Southern Nuclear Operating Company
Vogtle Electric Generating Plant Units 3 and 4
Request for License Amendment and Exemption Regarding
Hydrogen Venting from Passive Core Cooling System (PXS) Compartments (LAR-17-003)

**Request for License Amendment Regarding
Hydrogen Venting from Passive Core Cooling System (PXS) Compartments
(LAR-17-003)**

Request for License Amendment Regarding Hydrogen Venting from Passive Core Cooling System (PXS) Compartments (LAR-17-003)

Figure 3-1. Component Layout for Temperature Distribution

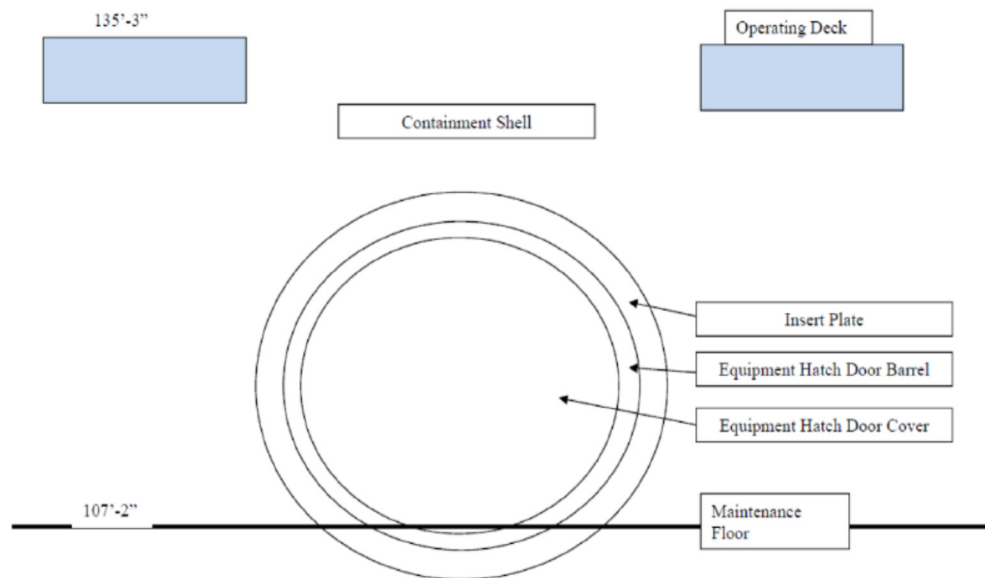
A one-dimensional heat transfer calculation was performed to evaluate temperature distribution on the containment vessel resulting from the diffusion flame hydrogen burn. A CFD analysis was also performed. Insights from the CFD analysis are only used if they point to a non-conservative assumption. Given the nature of the modelling, the flame can only be modelled at each vent location individually. The results of the one-dimensional calculation and the CFD model show the equipment access opening produces the highest temperature on the containment shell and equipment hatch. The analysis created two temperature distributions. The first distribution assumed that the plume creates a hot spot that spans the hatch cover, hatch barrel, insert plate and containment shell. The second distribution was developed based on the insights from the CFD analysis in which the hot spot occurs on the containment shell at the vent exit.

The hot spot is the local area where the burning plume flow impacts the containment pressure boundary. The heat transfer consists of radiation heat transfer and horizontal (flat plate in cross flow) and vertical (flat plate in parallel flow) convection. For the structural analysis, the surface temperatures within the hot spot are the bounding temperature limits of the containment shell and the hatch door cover. For the hatch barrel hot spot temperature, where the hatch seals are located, the average wall temperature was calculated and the corresponding surface temperature is reported. Zone 1 is the area of the containment pressure boundary above the hot spot in contact with the plume that flows up the containment wall. The heat transfer consists of radiation heat transfer and vertical (flat plate in parallel flow) convection. Zone 2 is the area of the containment pressure boundary below the hot spot where the containment shell is not in contact with the plume flow but is receiving radiation heat transfer from the plume. The resultant temperatures are shown in the table and figures below.

Figure 3-2. Temperature Distribution 1: Hot Spot on the Equipment Hatch

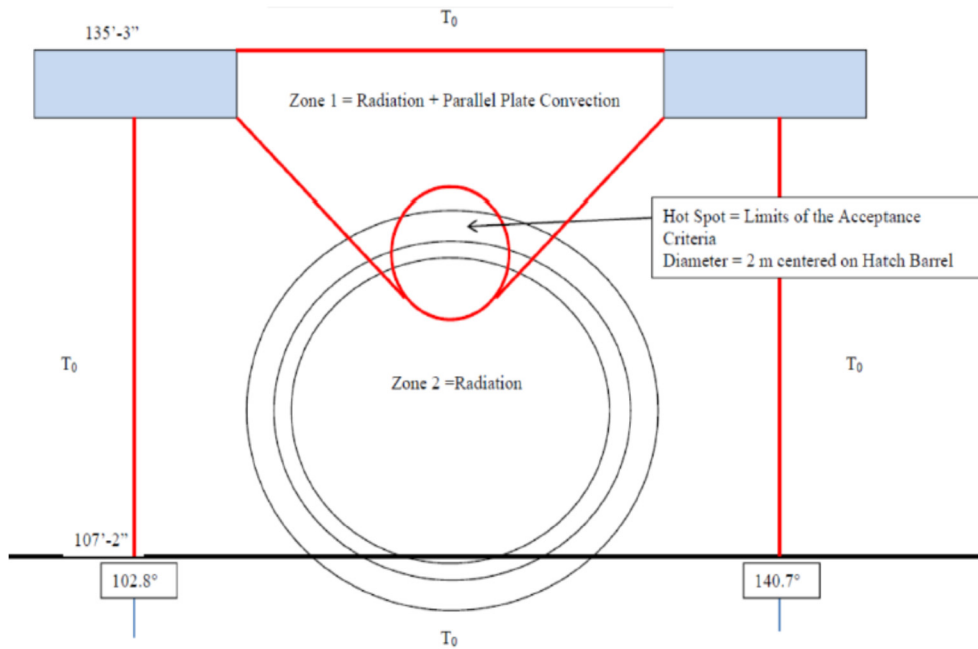
Peak Surface Temperatures (°F)			
Component	Hot Spot	Z1 = Radiation and Convection	Z2 = Radiation Only
Containment Shell	650	470	436
Insert Plate/Barrel	488**	366	344
Hatch Cover	800	591	543
Peak Average Wall Temperatures (°F)			
Component	Hot Spot	Z1 = Radiation and Convection	Z2 = Radiation Only
Containment Shell	607	442	411
Insert Plate/Barrel	390**	308	293
Hatch Cover	780	577	530
